Midway City Council
20 July 2021
Regular Meeting

Resolution 2021-13 /
Street Cross-Sections

To: Mayor Johnson and City Council
From: Wes Johnson
Date: July 16, 2021 **Memorandum**
Subject: Memo Regarding Midway City Standard Roadway Widths

A RESOLUTION BY THE MIDWAY CITY COUNCIL ADOPTING AN UPDATED STANDARD SPECIFICATIONS AND DRAWINGS FOR THE CITY OF MIDWAY

**LOCAL STREET CROSS SECTION #1
COMMERCIAL & BUSINESS**

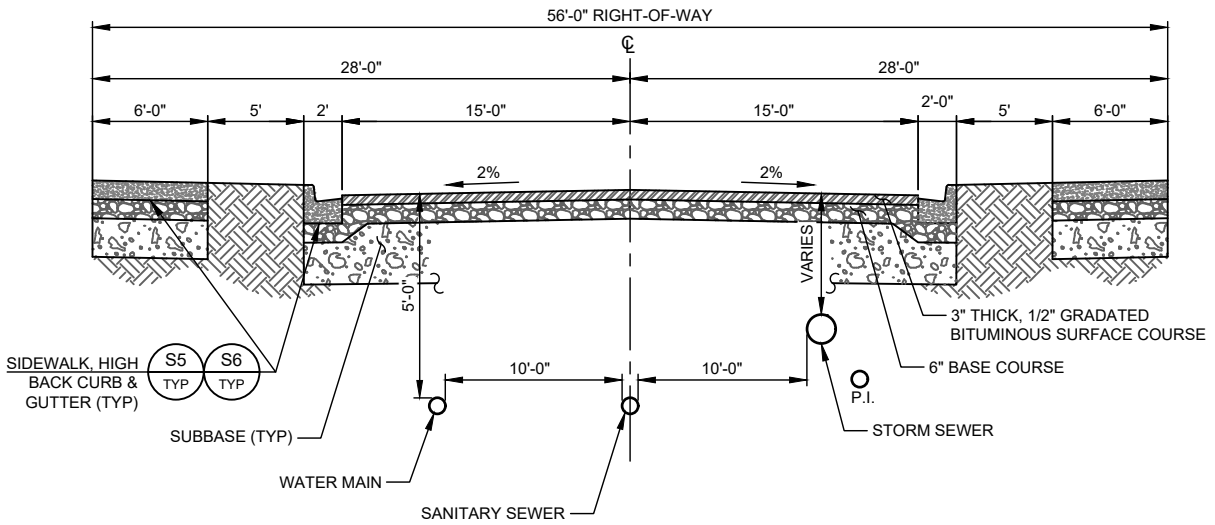
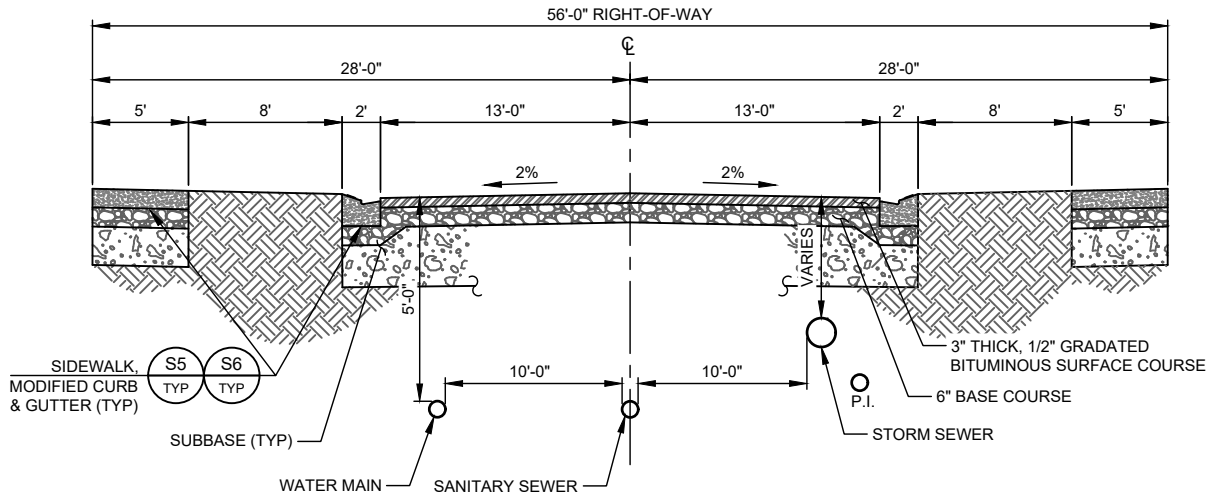
1. Local Street Cross Section #1 for Commercial Business
 - a. It is proposed to leave the asphalt cross section as shown. This will accommodate parking and allowing vehicles to open doors without causing issues for cars driving on the street.

LOCAL STREET CROSS SECTION #2

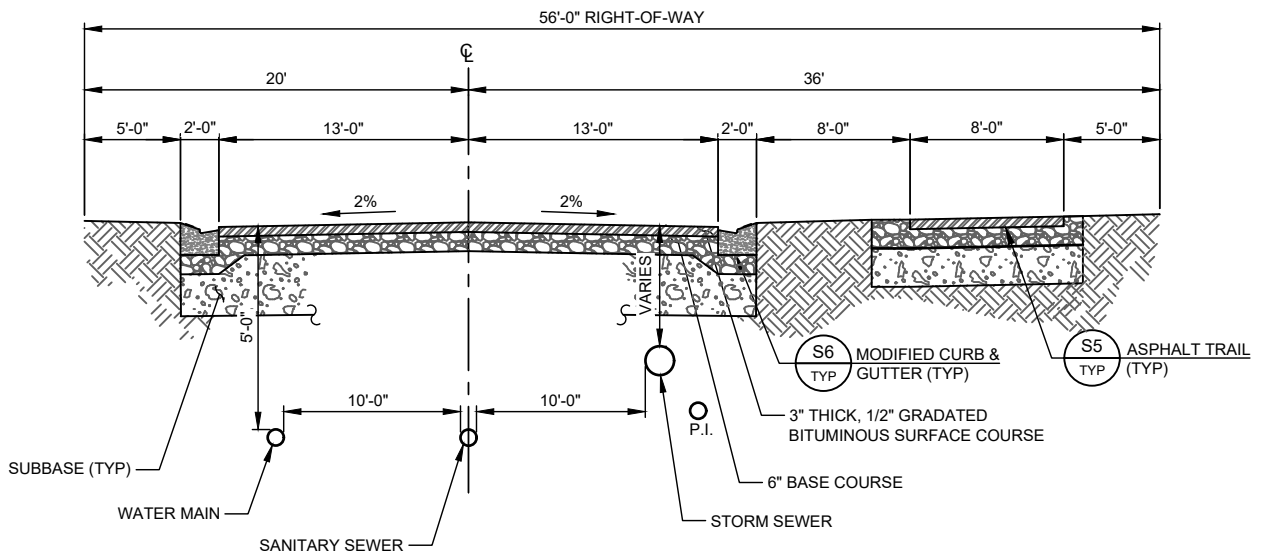
2. Local Street Cross Section #2
 - a. Reduce the required cross section width of asphalt from 30' to 26'.
 - b. Take the reduction in asphalt width and add it to the park strip. This would take the park strip from 5' wide to 7' wide.

LOCAL STREET CROSS SECTION #3

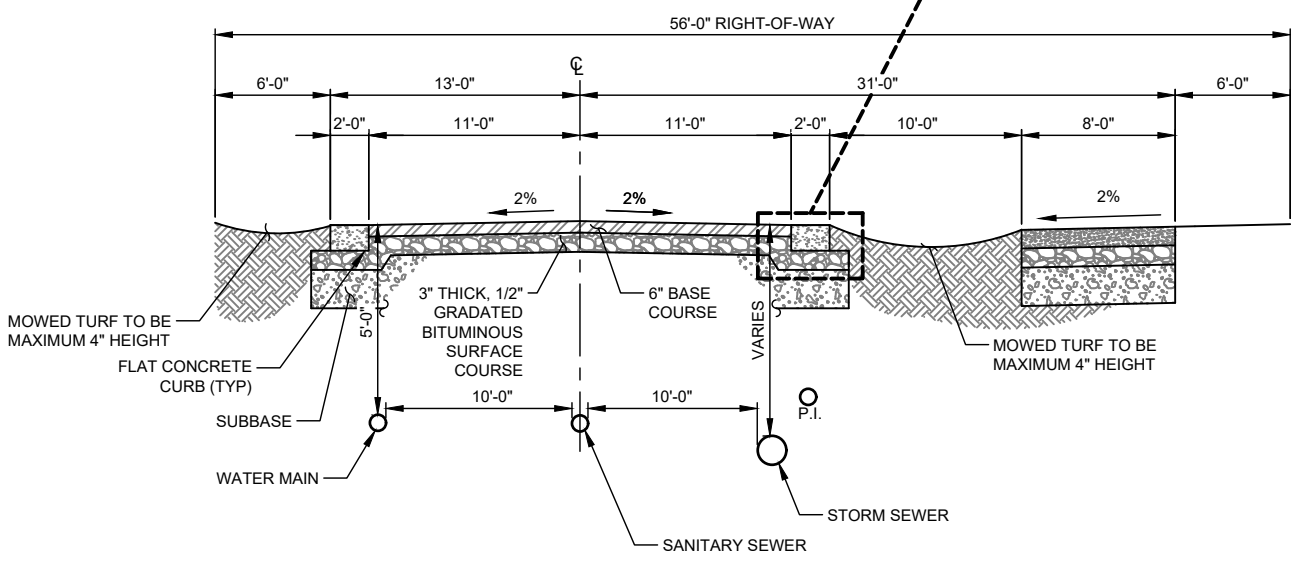
3. Local Street Cross Section #3
 - a. Reduce the required cross section width of asphalt from 30' to 26'.
 - b. Take the reduction in asphalt width and add it to the park strip.

- c. With a only a trail on one side of the road.
 - d. The road is shifted to the left so that the left side of the cross-section distance from the curb and gutter to the ROW equals the right-side distance of the outside edge of the trail to the ROW.

LOCAL RURAL STREET CROSS SECTION #4

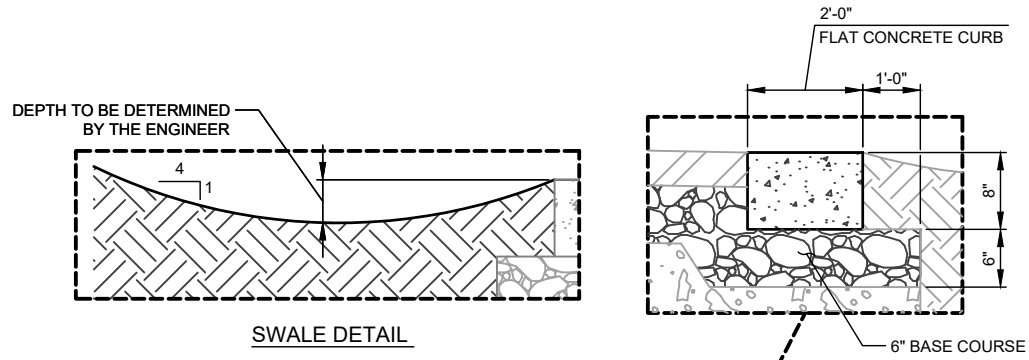
We met with Councilmen Simons, Councilmen Payne, and the planning staff regarding the Midway City standard roadway widths. The engineering department supports the proposed changes however our recommendation for local rural street asphalt cross section be increased from 20' to 22' of asphalt. Below is a summary of our discussion with the attached cross sections:

4. Local Rural Street Cross Section #4
 - a. To qualify for this cross section the frontage requirement has been reduced from 150' to 105' and must be approved by City Council.

- b. Reduce the required cross section width of asphalt from 30' to 20'. With a 2' ribbon curb on each side.
 - c. Take the reduction in asphalt width and add it to the park strip.

- d. With a only a trail on one side of the road.
 - e. The road is shifted to the left so that the left side of the cross-section distance from the curb and gutter to the ROW equals the right-side distance of the outside edge of the trail to the ROW.
